# Access Compliance Report

## Public Rights-of-Way

Intersection ID: 2412	Main Street: HIDDEN_MEADOW_LN	Cross Street: LAUREL_RUN_DR	Location:	N
ADA ID: A9515B9FC6C5	Ramp Type: PerpDiag	Initial Pass/Fail: Fail	Overall Compliance: No	Severity Score: 8.75

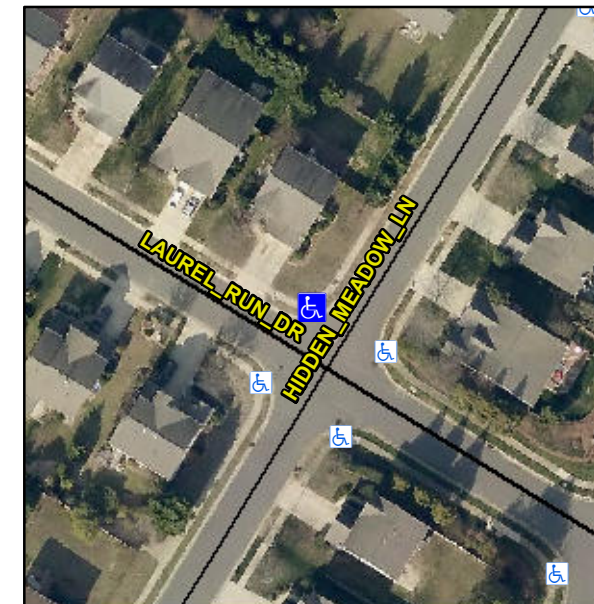
**Not Found, R304.5.1**

Compliance	Description	Data	Compliance	Description	Data
N/A	Ramp Length (in)	48.0	Yes	Ramp Slope (%)	7.0
No	Ramp Width (in)	46.0	Yes	Ramp XSlope (%)	0.3
N/A	Flare Type LT	N/A	N/A	Flare Type RT	N/A
N/A	Flare Slope LT (%)	N/A	N/A	Flare Slope RT (%)	N/A
N/A	Flare Traversable LT?	N/A	N/A	Flare Traversable RT?	N/A
N/A	Landing Length (in)	N/A	N/A	DWS Provided?	N/A
N/A	Landing Width (in)	N/A	N/A	DWS Contrast?	N/A
N/A	Landing Slope (%)	N/A	N/A	DWS Length (in)	N/A
N/A	Landing X Slope (%)	N/A	N/A	DWS Full Width?	N/A
N/A	Landing Curb? (Y/N)	N/A	N/A	DWS Offset (in)	N/A
N/A	Shared Landing?	N/A			
N/A	Gutter Ponding?	N/A	N/A	Gutter Slope (%)	N/A
N/A	Gutter Lip Ht (in)	N/A	N/A	Gutter X Slope (%)	N/A
N/A	Painted X Walk1?	No	N/A	Painted X Walk2?	No
	X Walk 1 Direction	To SW		X Walk 2 Direction	To SE
N/A	X Walk 1 Width (in)	N/A	N/A	X Walk 2 Width (in)	N/A
	X Walk 1 Slope (%)	3.9		X Walk 2 Slope (%)	2.0
	X Walk 1 X Slope (%)	3.1		X Walk 2 X Slope (%)	3.1

**Remove & Replace Curb Ramp With Two New Directional Ramps or Equivalent.**
